Artemis -

We are losing sleep at night over the closeness of our house to the path.

Could you please check out the topography regarding the possibility of shifting our bedroom wing as follows:

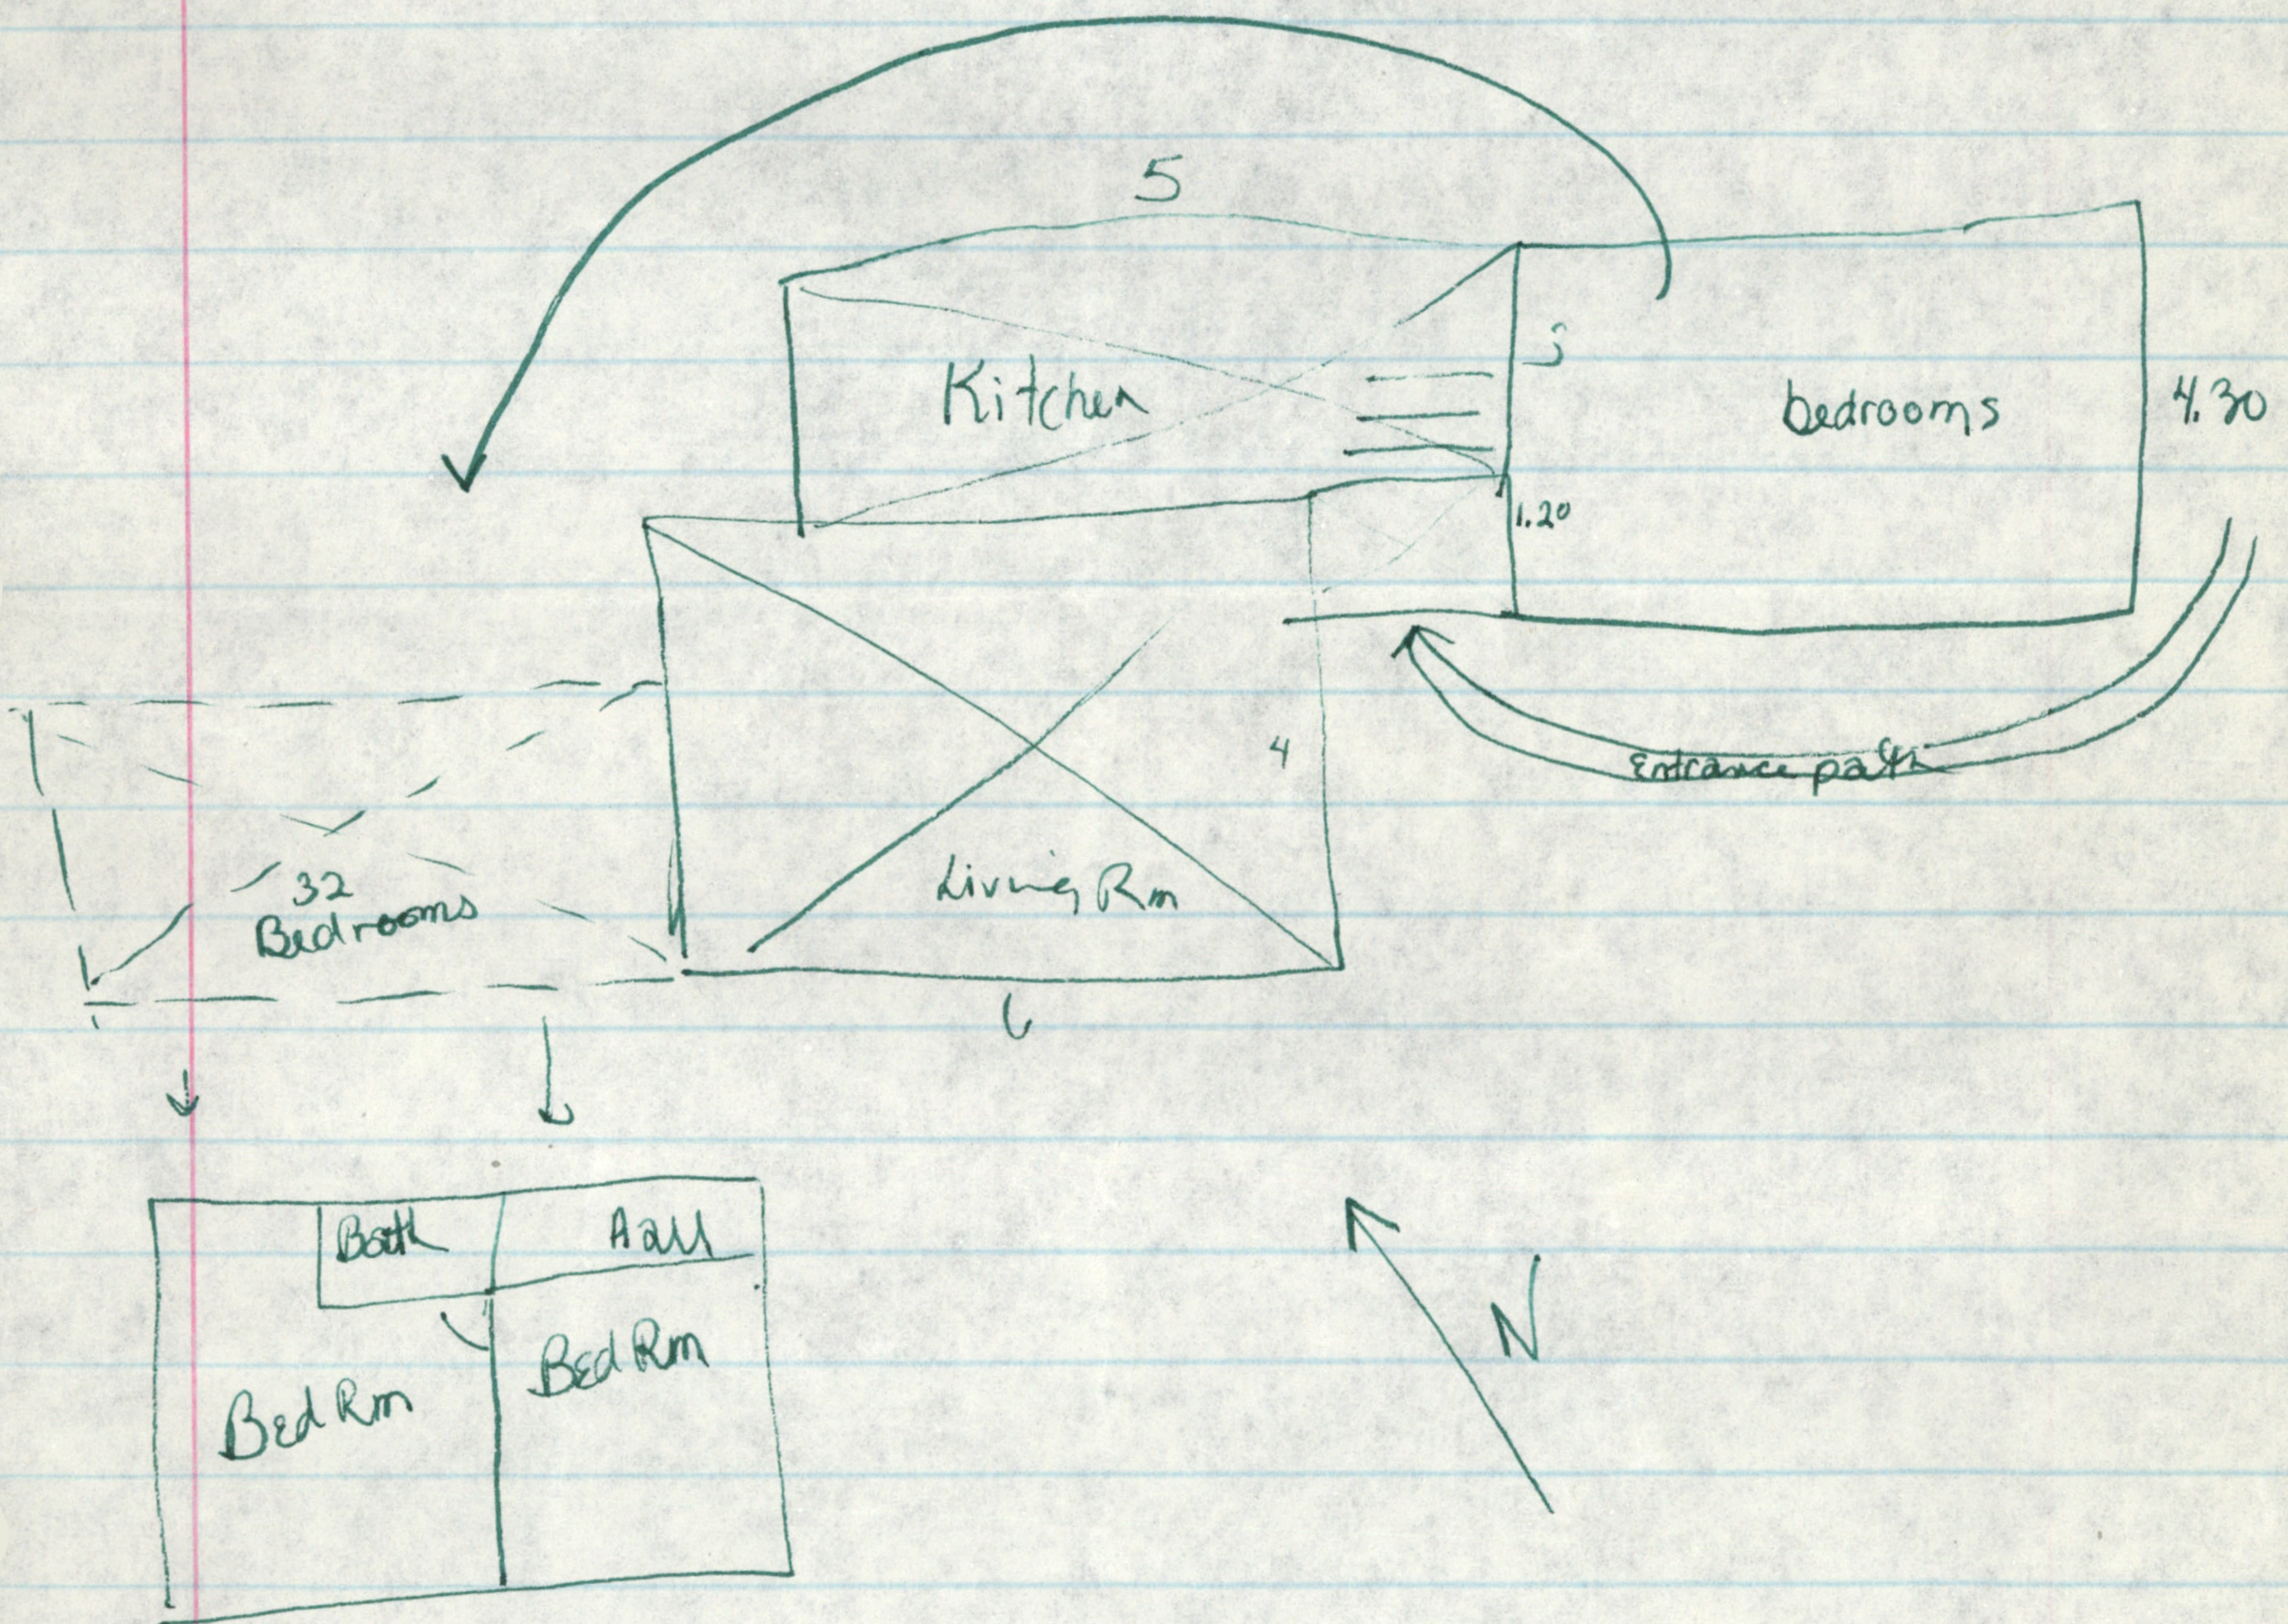
1. In living Room remove alcove & shorten by  $\frac{3}{4}$  meter on west elevation  
Add  $\frac{3}{4}$  meter to wind room on west elevation

Widen bedroom wing on south side to 6.25 m.

2. raise living room to same level as kitchen so windroom is one step down from living room & from kitchen.

3. eliminate 1 window on south wall of living room

4. on west wall of living room make double doors

5. Add overhang to front door

6. Add closet (even  $\frac{1}{2}$  height) at entrance under Bedroom wing

7. eliminate kitchen ~~living room~~ pass through

BELLINI

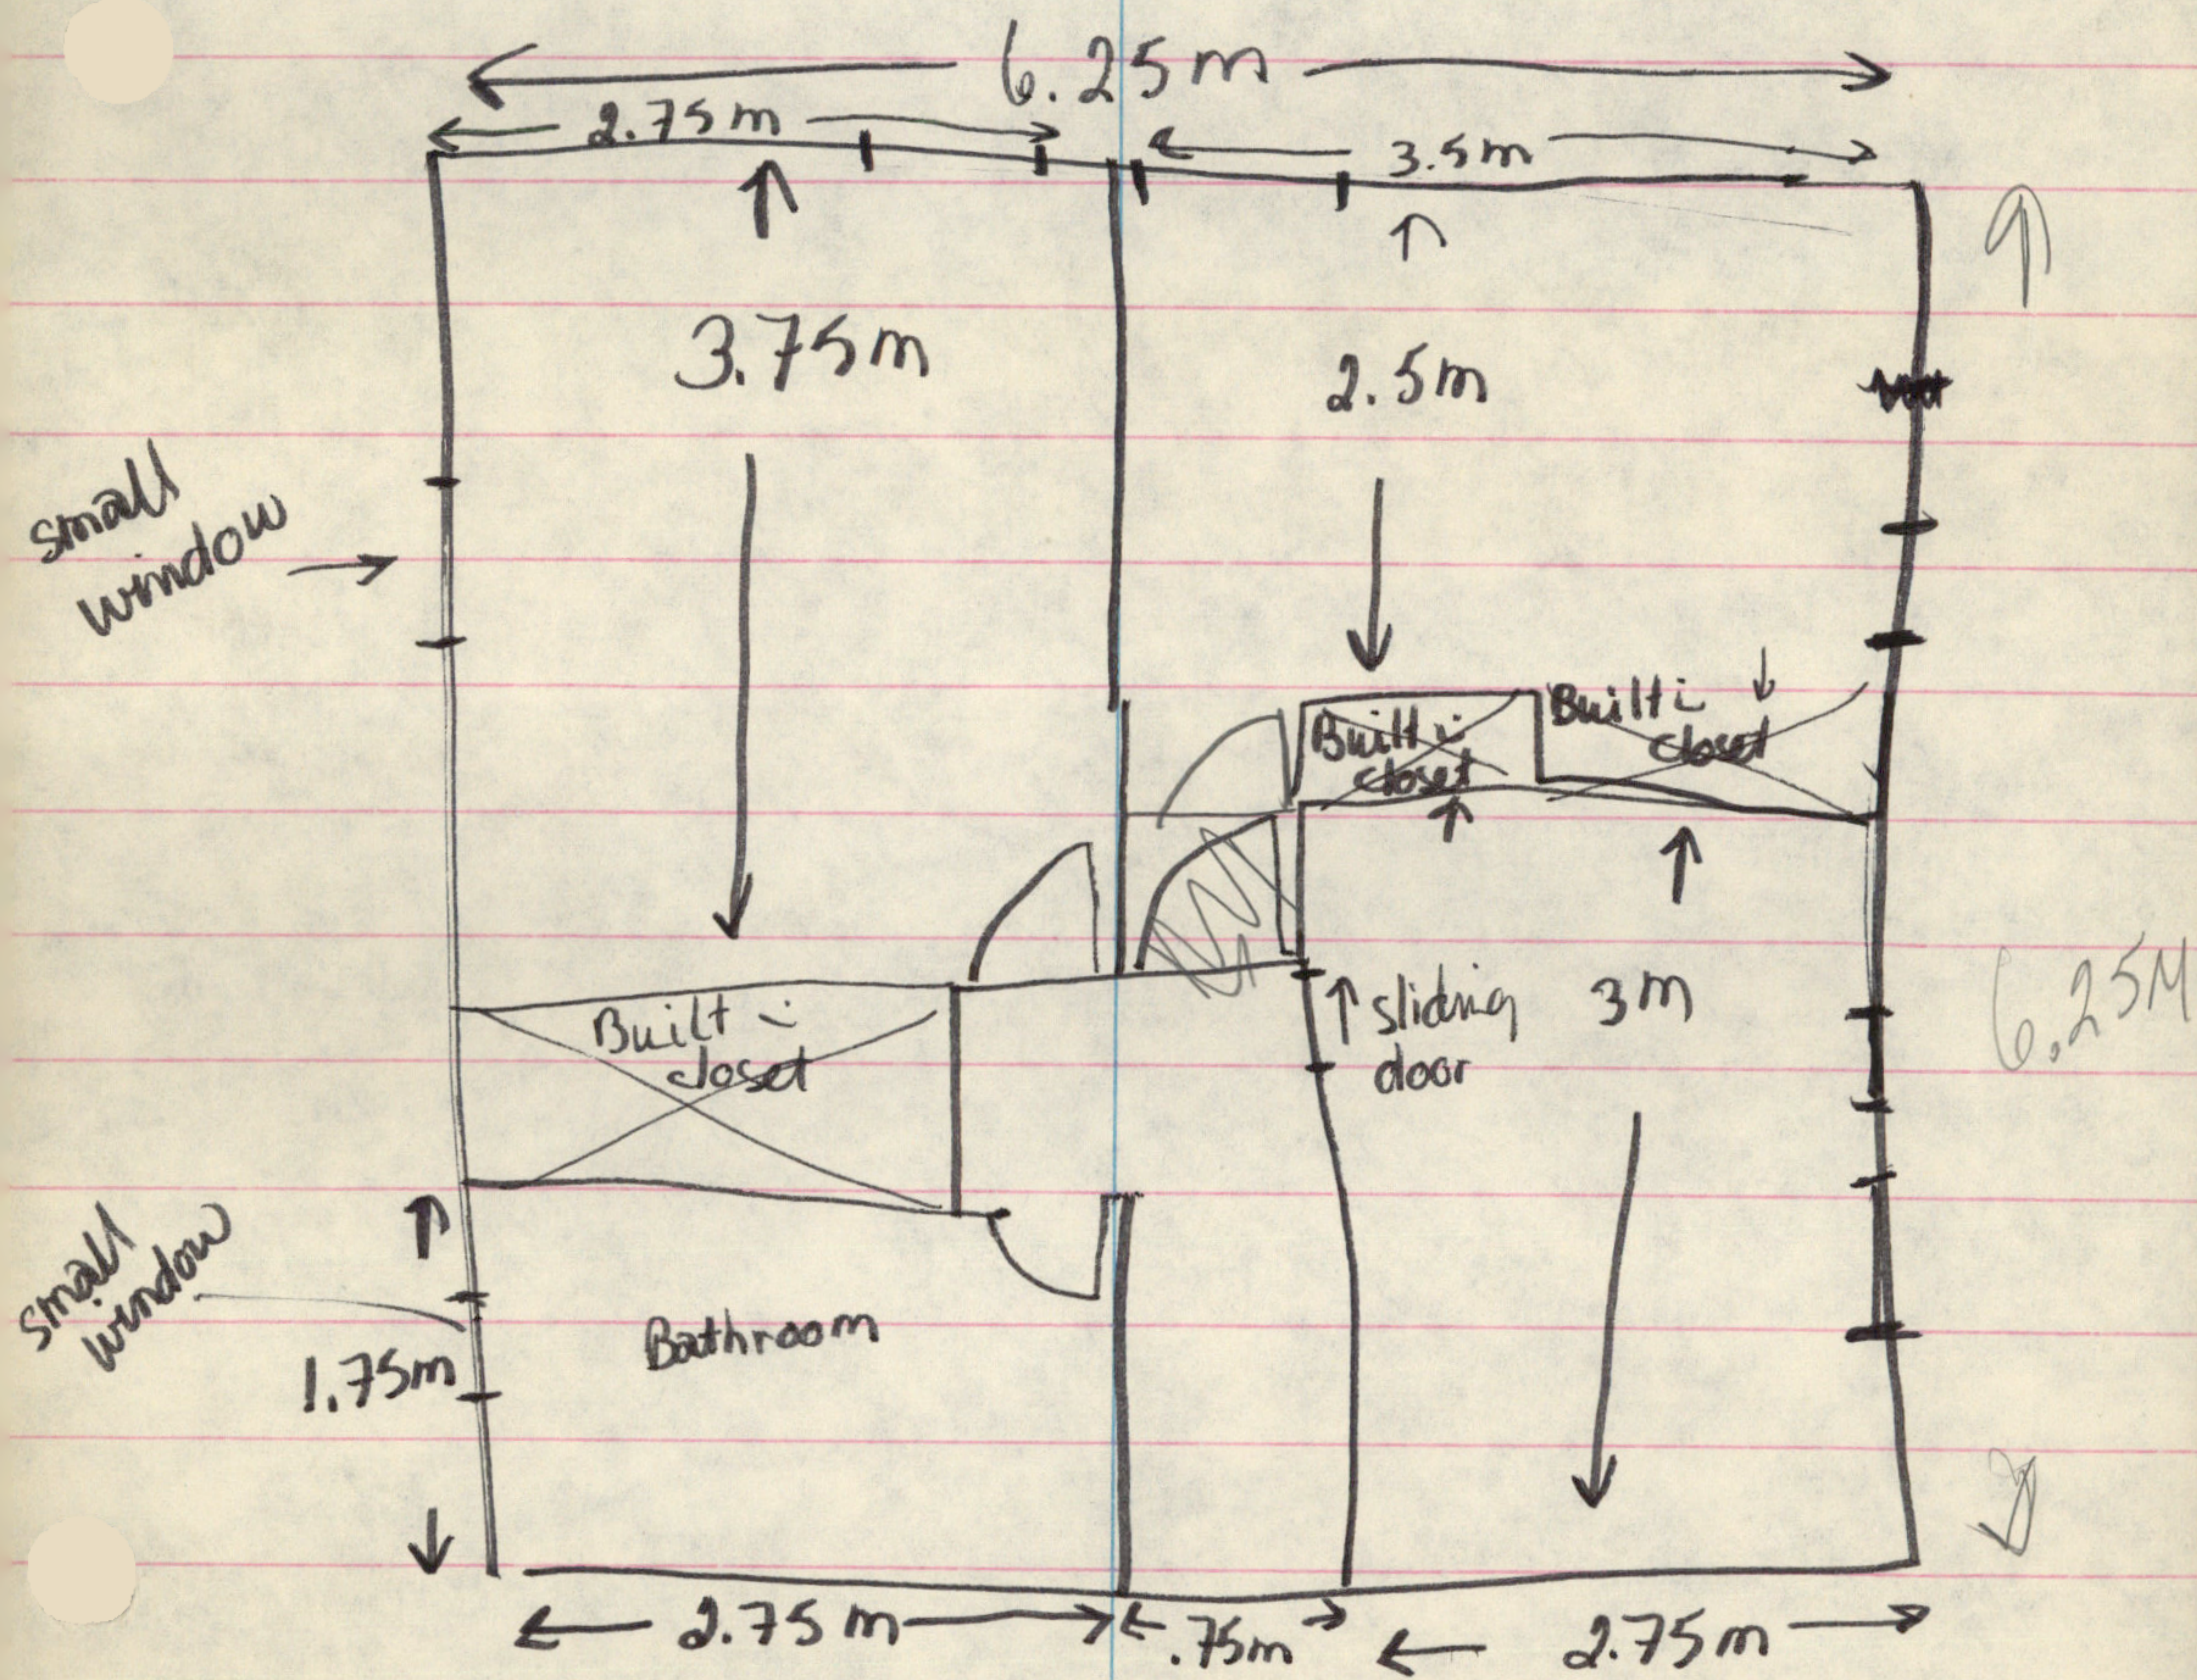
8. Add storage above bathroom & backdoor area

9. top entry step should be same level as front entrance

10. Redo bedrooms as shown

11. Kitchen to windroom - eliminate window  
& move doors to where window was.

12. move windroom/living room door as far  
west as possible

13. eliminate (or at least reduce to one) steps  
between living room & windroom  
by raising level of living room (see #2)

14. eliminate entry hall steps & <sup>make</sup> narrower  
entrance to kitchen

15. The proximity of the NE corner of house  
to the path seems closer than planned &  
is still disturbing. Any suggestions?
